Emergency Airworthiness Directive

AD No.: 2018-0265R1

ATA 72 – Engine – Exhaust Valve – Replacement

Exchange of exhaust valves on ROTAX® Engine Types 915 i A, 915 i B (Series) and 914 (Series)

Fig. 1
Exchange of exhaust valves

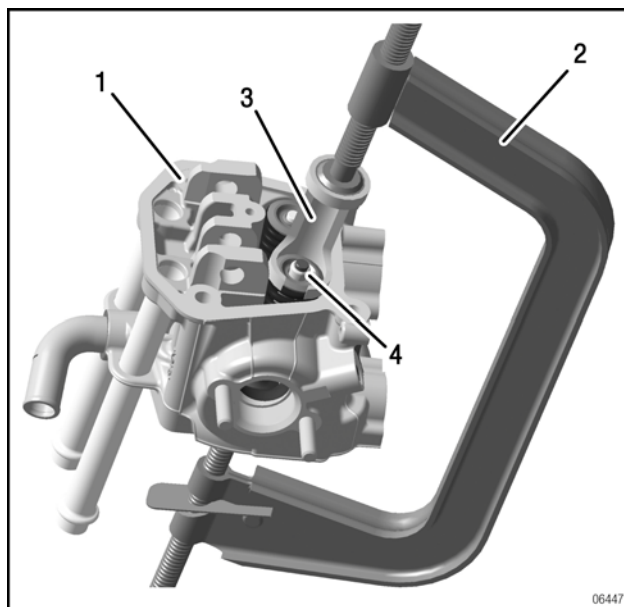
Step	Procedure
1	Remove the affected exhaust valves according to relevant Maintenance Manual Heavy (MMH).
2	Install new exhaust valves according to relevant Maintenance Manual Heavy (MMH).

Fig. 2
Identification of exhaust valves

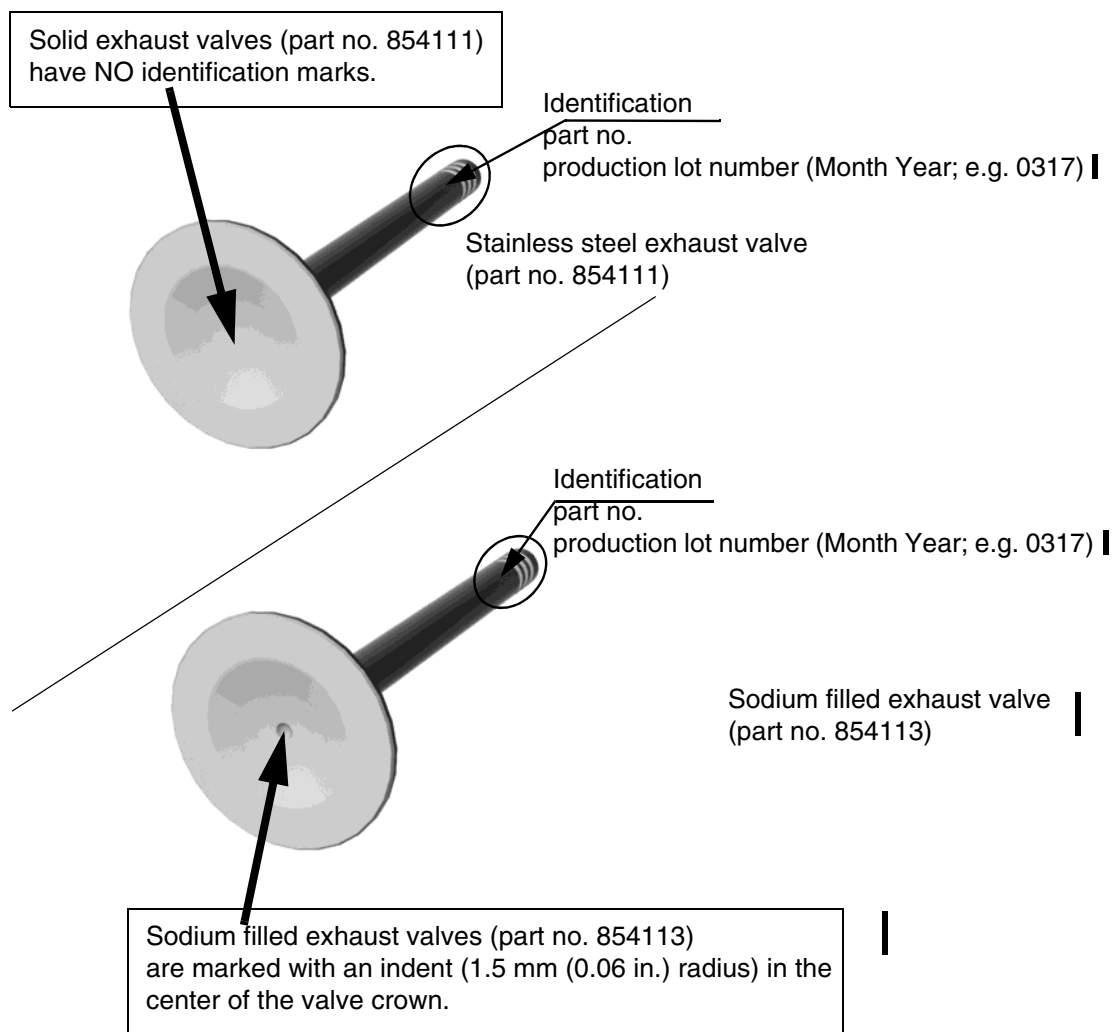
The engines below have been fitted by the manufacturer with an exhaust valve 32 mm (1.26 in.) part no. 854113 with a variety of production lots from which the production lot numbers 0317 and 0517 (see Fig. 2) are affected.

All engines are affected, which have been equipped with an exhaust valve 32 mm (1.26 in.) with part no. 854113 with a production lot number 0317 and 0517 during engine repair, maintenance or general overhaul (see Fig. 2).

- All affected parts cannot further be used and must be marked unserviceable. These parts must be returned FCA (Free CArrier) to ROTAX[®] Authorized Distributors or their independent Service Centers
- Further sale, use or shipment of all affected exhaust valves part no. 854113 (see section 1.1) in stores (e.g. replacement parts) is not allowed and must be returned FCA to ROTAX[®] Authorized Distributors or their independent Service Centers
